STAFF REPORT
(ONE STEP Preliminary-Final Plat)

CASE NUMBER: S/D 96-39 POWER CDC ADDITION

STAFF REPORT
(Revised Final Plat, Final Plat Approved 7/3/96)

CASE NUMBER: S/D 96-39 - POWER CDC ADDITION

VICINITY MAP:

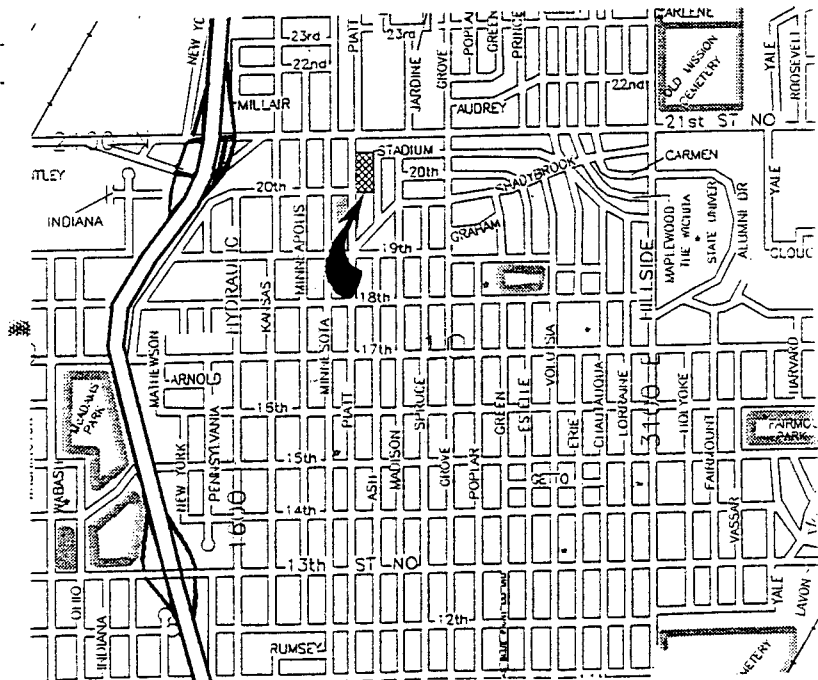
- A. In order to allow for a street right-of-way of 32 feet and a 29-foot paved surface, the applicant shall either submit a request for a zone change to an appropriate zoning classification (SF-6 or TF-3) or submit a covenant restricting each lot to such a use.

- D. The applicant shall guarantee any drainage improvements required by the platting of this property.
- E. The applicant shall guarantee the paving of the proposed interior streets. **City Engineering** needs to comment on the street's (Hope Ct.) non-standard right-of-way at the entrance from Piatt. That is, are there any special requirements involved in paving, design, maintenance, use, etc. of the expanded area of right-of-way.

- H. Since this plat proposes the platting of narrow street right-of-way with adjacent "15-foot street, drainage and utility easements," a restrictive covenant shall be submitted which calls out restrictions for lot-owner use of these easements. Retaining walls and change of grade shall be prohibited within these easements as well as fences, earth berms and mass plantings. Any plantings within the easement shall be reviewed by the City Forestry Division prior to installation.

- I. On the final plat tracing, this plat's street shall either be named Piatt Court or if an existing street name east of Piatt is used, such street shall be indicated as a Circle (e.g., Ash Circle). The use of Hope in an area of existing street names cannot be supported by Staff.

- J. On the final plat tracing, additional information shall be shown for this site's street right-of-way. That is, the 32-foot right-of-way needs to be shown along the street's main section and the radius of the cul-de-sac needs to be shown.

- K. The court's (circle's) entrance at Piatt shall be shown as a dashed line or left open. Solid lines are intended to indicate a street is being platted as a private street (Reserve).

- L. On the final plat tracing, lot numbers around the cul-de-sac should be continuous, i.e, going from Lot 4 to Lot 5, etc. and not from Lot 4 to Lot 8.
- M. On the final plat tracing, the title "Deputy" shall be deleted from the City Clerk's signature line.
- N. The final plat shall reference a tie point to a previously platted lot corner or section corner.
- O. Except for lots platted adjacent to arterials, double frontage lots (lots with a front and rear property line along 2-streets) are, according to the Subdivision Regulations, to be avoided. This site is, however, attempting to replat the site into a somewhat private, internally oriented property rather than simply laying out lots along Piatt and Ash. Approval of this plat will, however, require the Subdivision Committee's/MAPC's waiving of the design standard for Lots with double frontages.

VICINITY MAP

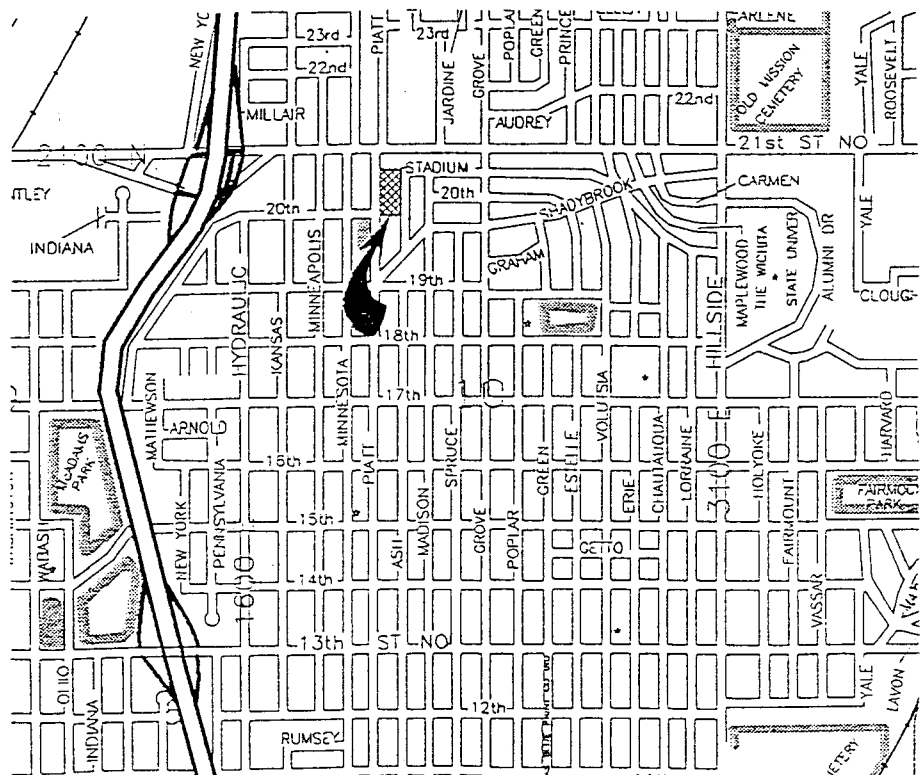
- Abandon existing petitions, Guarantee SS,*
- A. City Engineering needs to comment on the existing guarantees for the extension of sanitary sewer and City water and any requirements for providing new guarantees.

- C. City Engineering needs to comment on the status of the applicant's drainage plan.
 - D. The Applicant is reminded that a platting binder is required with the final plat. Approval of this plat will be subject to submittal of this binder and any relevant conditions found by such a review.

- E. The lot numbers should be revised to include consecutively numbered adjoining lots.
 - F. The platting text shall include language that a drainage plan has been developed for the plat and that all drainage easements, rights-of-way, or reserves shall remain at established grades or as modified with the approval of the applicable City or County Engineer, and unobstructed to allow for the conveyance of stormwater.
